Land South of The Hill, Littlebourne – Proposed Puffin Crossing

Design Team Response to Stage 1 Road Safety Audit – Reference NS23/898/RSA1

APPENDIX A – UPDATED DRAWING (ITM16283-GA-022D)

DRAWN: JB	CHECKED: JW	APPROVED: VE
PROJECT No: ITM16283	SCALE @ A3: 1:500	DATE: 24.08.23
DRAWING No: ITM16283-GA-022		REV: D

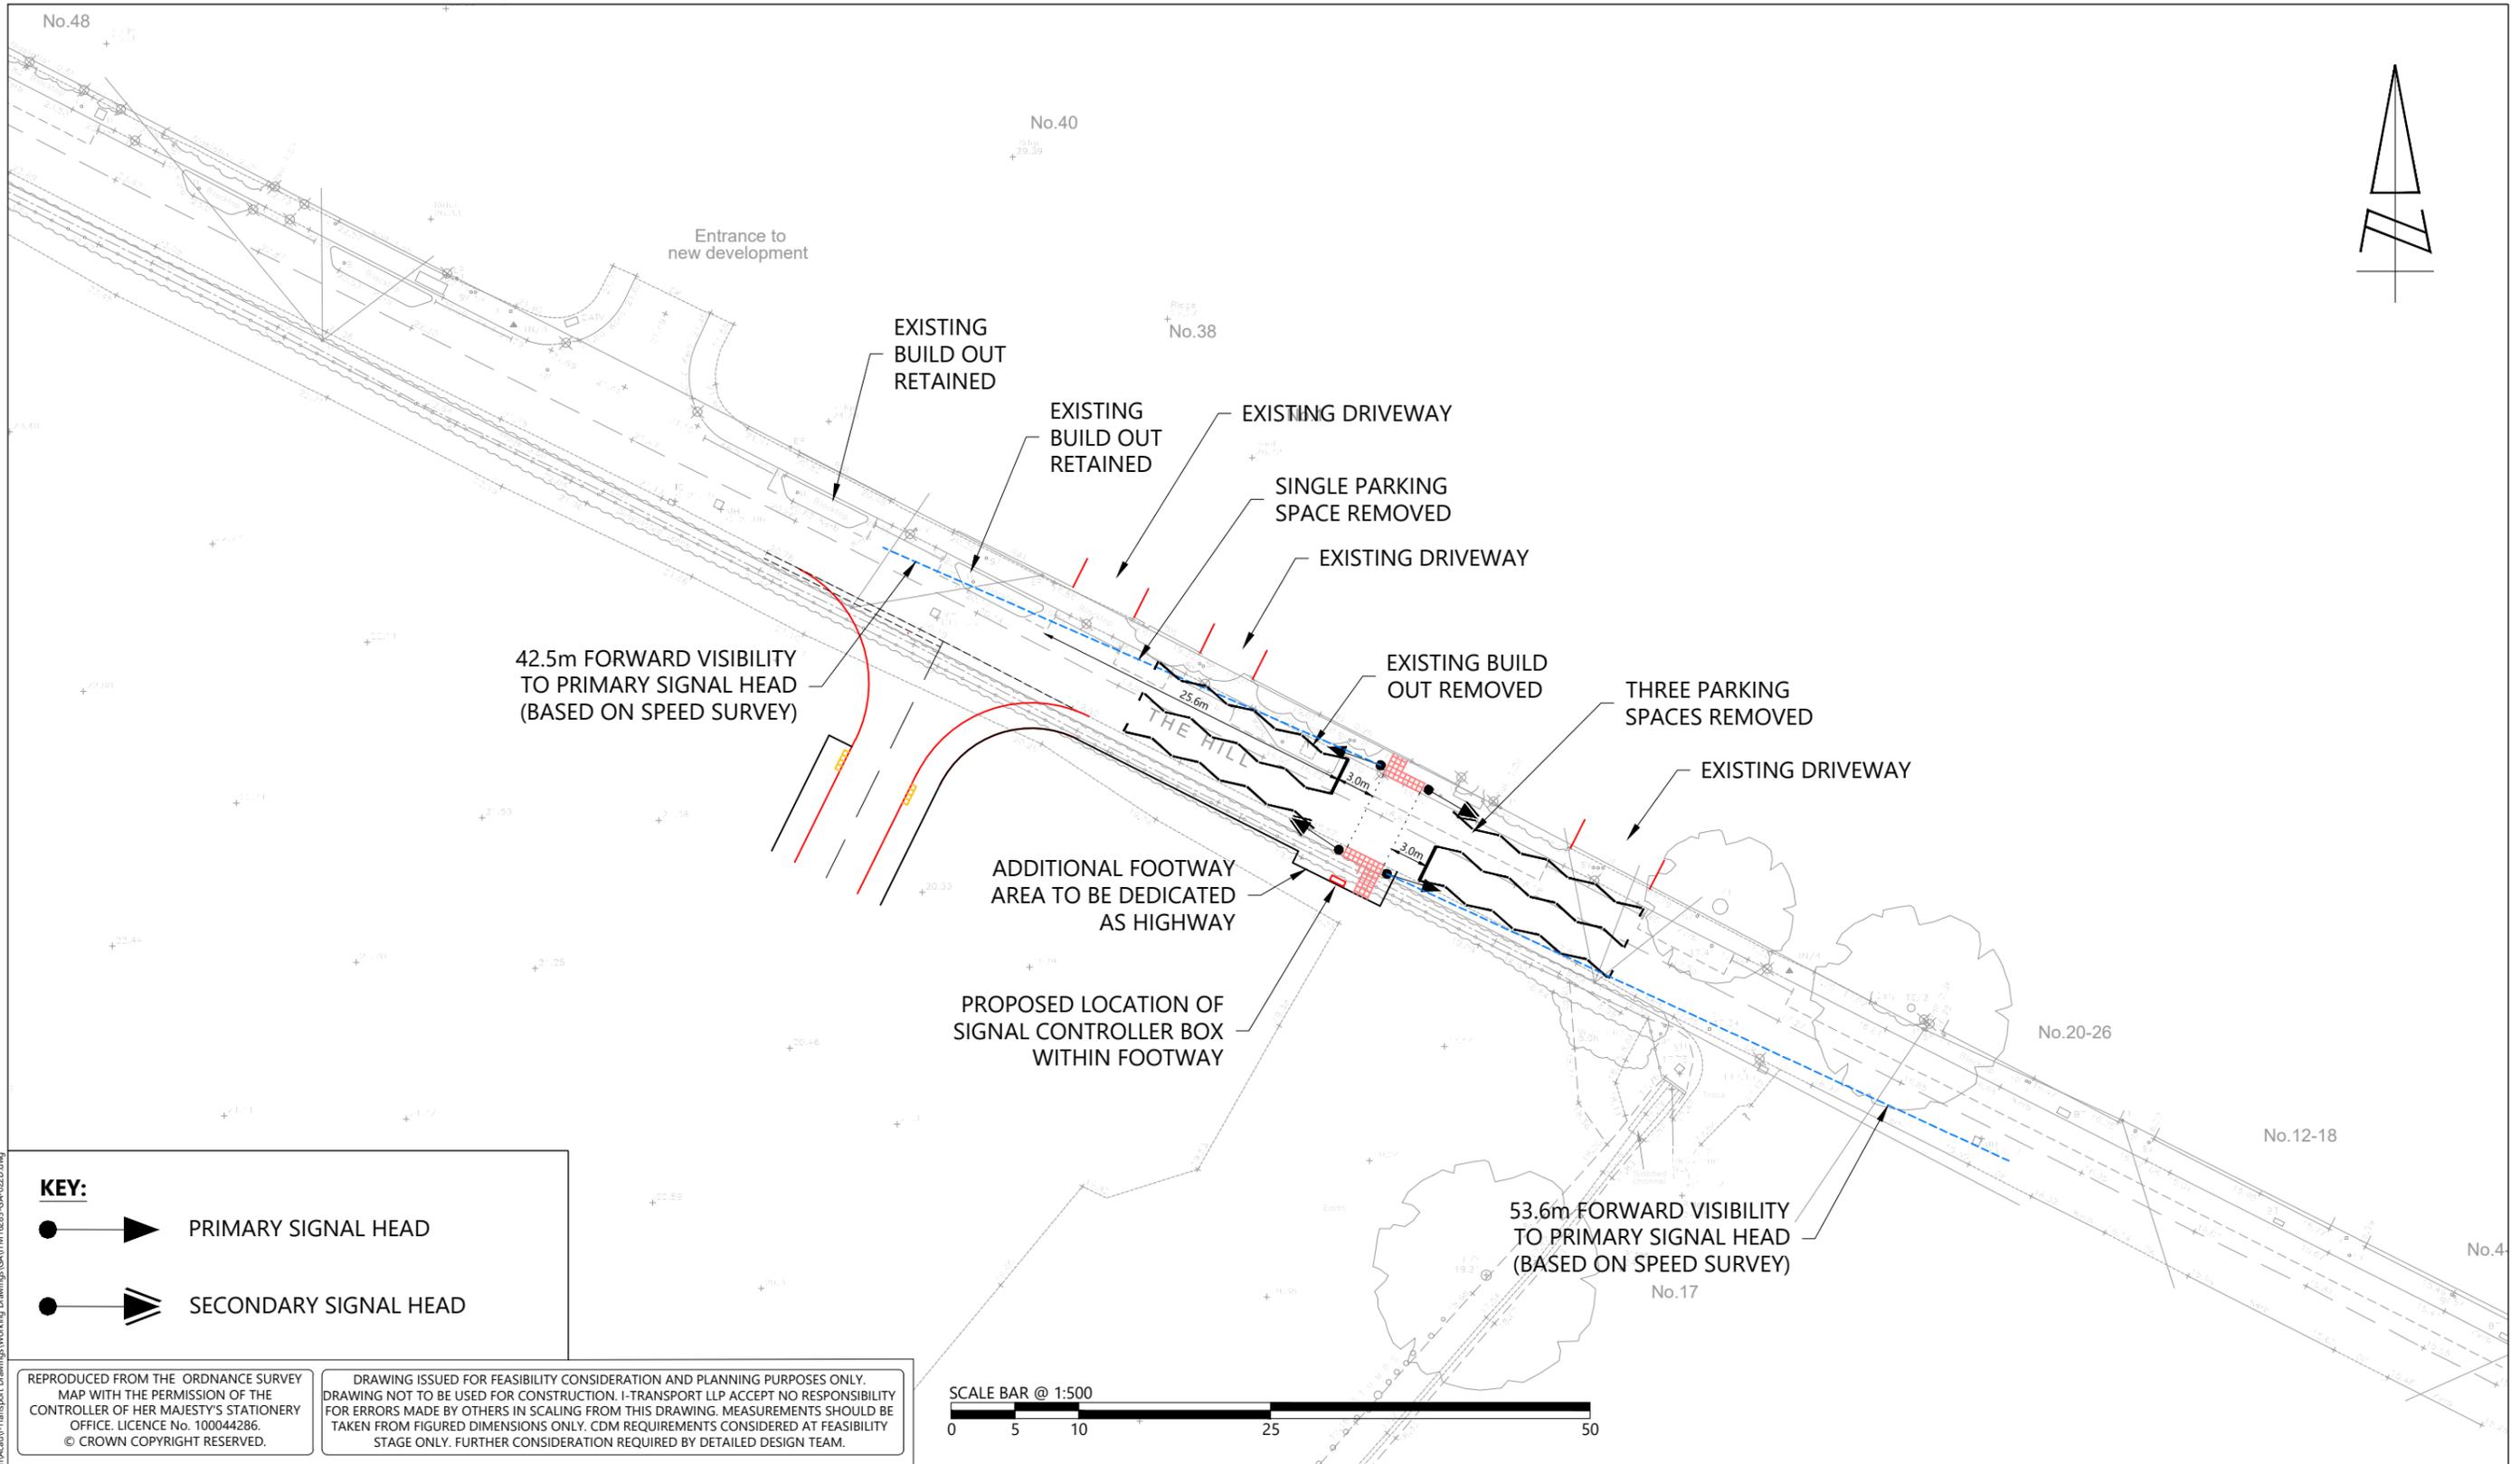
Proposed Puffin Crossing at Land South of the Hill, Littlebourne				
	Location	Problem	Recommendation	Design Team Response
3.1	The westbound approach to the Puffin crossing	<p>Summary: Sufficient forward visibility to the crossing should be provided.</p> <p>Given the straight alignment of The Hill, forward visibility of the crossing (and hence the stopping sight distance) should be achievable. However, there is heavy shrubbery on the south side of the road, and the measured average 85%ile westbound speed is just under 35mph. Providing sufficient visibility will reduce the risk of overshoots or sudden braking at the crossing.</p>	<p>It is recommended that the forward visibility of the crossing is specified as appropriate for the measured approach speeds, and that any potential obstructions are either relocated or removed.</p>	<p>Recommendation accepted.</p> <p>The Manual for Streets SSD for 35mph is 53.6m. The westbound visibility splay shows that hedge which runs along the south kerb of the carriageway does not impact the forward visibility, based on the topographical survey.</p> <p>In addition, the hedge is within Applicants control and will be maintained to ensure the forward visibility is not obstructed.</p> <p>The visibility splays are shown in the updated drawing appended (ITM16283-GA-022D).</p>

Proposed Puffin Crossing at Land South of the Hill, Littlebourne				
3.2	The approaches to the Puffin crossings on The Hill	<p>Summary: The proximity of the vehicle stop lines to the crossing could increase the risk of vehicles striking pedestrians.</p> <p>The distances between the pedestrian crossing studs and the vehicle stop lines are not specified on the drawings at this stage, and it is possible that they could be laid in close proximity during construction. Accidents can occur at signal-controlled crossings because drivers of high fronted vehicles can pull away unaware of the presence of pedestrians, particularly those who are slow moving and who cross close to their vehicles. This problem can be mitigated by ensuring that adequate visibility of pedestrians is available to drivers and given effect by providing sufficient distance from the stop line to the crossing studs.</p>	It is recommended that the stop lines are specified as a minimum distance of 3m from the crossing studs (2.5m from the primary signal post) and shown as such on the drawings.	<p>Recommendation accepted.</p> <p>The distance between the crossing studs and stop lines are shown at 3.0m, as discussed with KCC and dimensions have been added to the updated drawing (ITM16283-GA-022D, appended).</p>
